5928-02-20074
September 30, 2002

Three Mile Island, Unit 1 (TMI Unit 1)
Facility Operating License No. DPR-50
NRC Docket No. 50-289

SUBJECT: License Amendment Request (LAR) No. 300 – Containment Isolation Valve
Technical Specifications and Administrative Changes

**TMI Unit 1 License Amendment Request (LAR) No. 300
Safety Evaluation and No Significant Hazards Consideration**

AmerGen
Extended Plot Plan
Three Mile Island Nuclear Station
Fig. 51

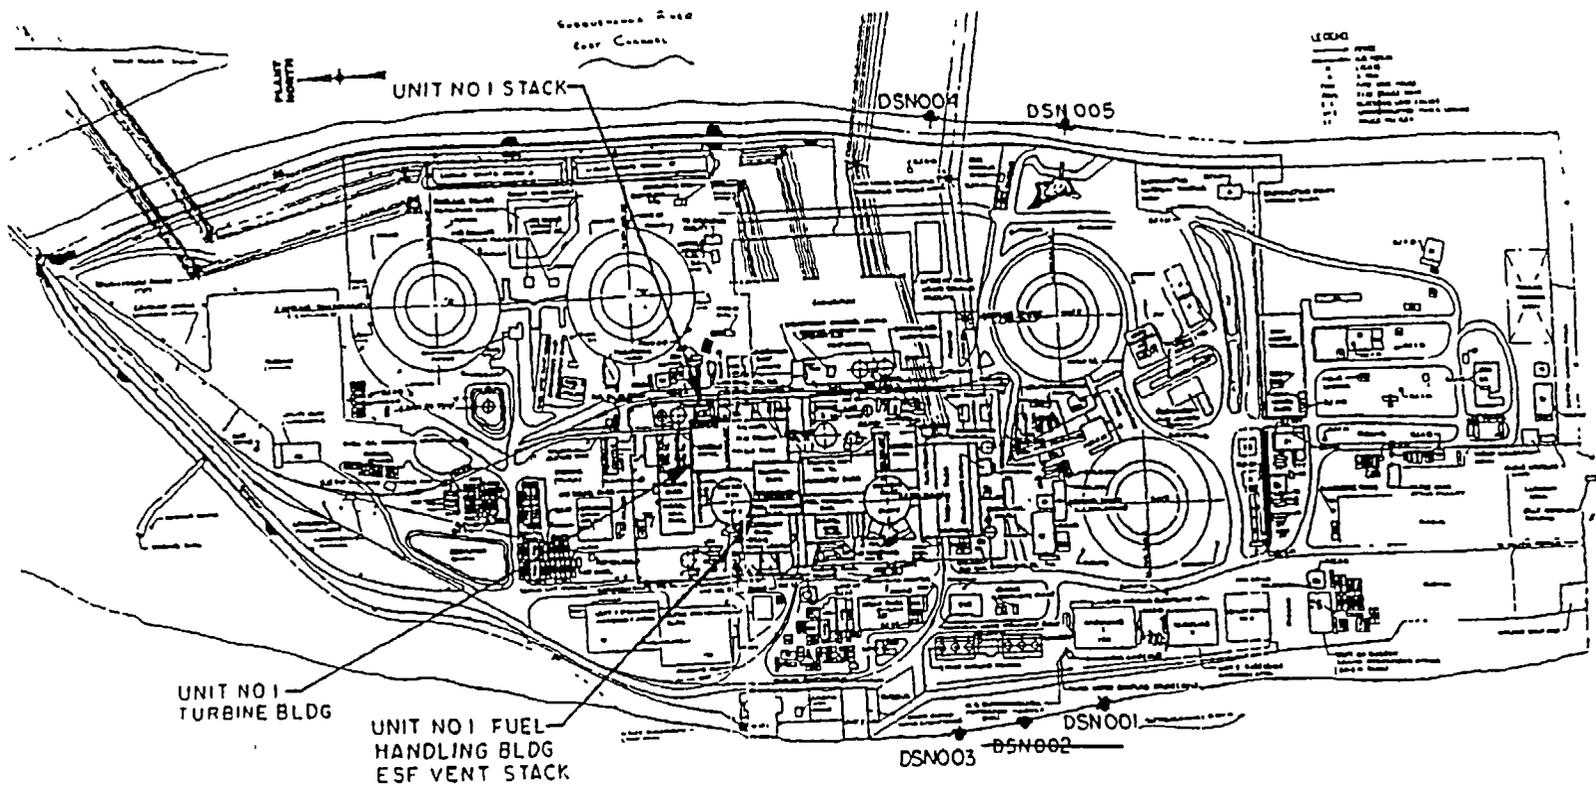
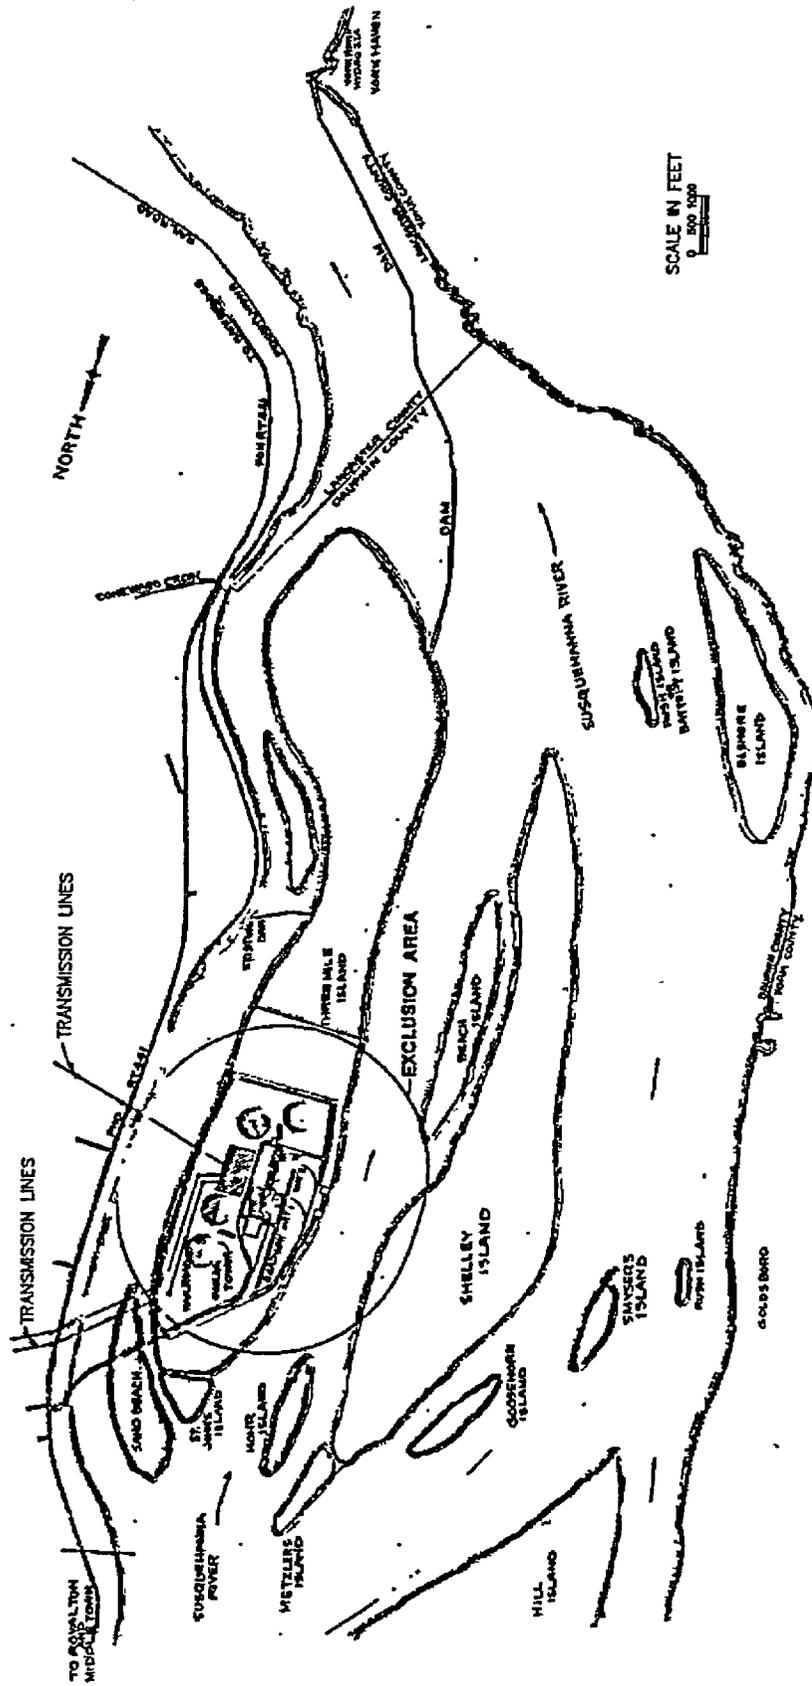
This figure is being revised to show the "transmission lines" leaving the TMI Unit 1 site and to delete the destination (name) of the transmission lines which is incorrect as shown. The current figure shows the destination of transmission lines that do not exist as labeled. Since the text of UFSAR Section 8.2.1 provides a correct detailed description of the electrical transmission network, there is no need to provide the number and destination of the transmission lines on the extended plot plan.

TS Figure 5-1 is being revised to delete the detail regarding transmissions line destinations leaving the TMI Unit site and label them "transmission lines." The additional detail is not used and has been found to be inaccurate. Since the text of UFSAR Section 8.2.1 provides a good verbal description of the existing transmission lines and their destinations, there is no need for this detail on Figure 5-1, "Extended Plot Plan. Therefore the label on this figure is being changed to read, "Transmission Lines."
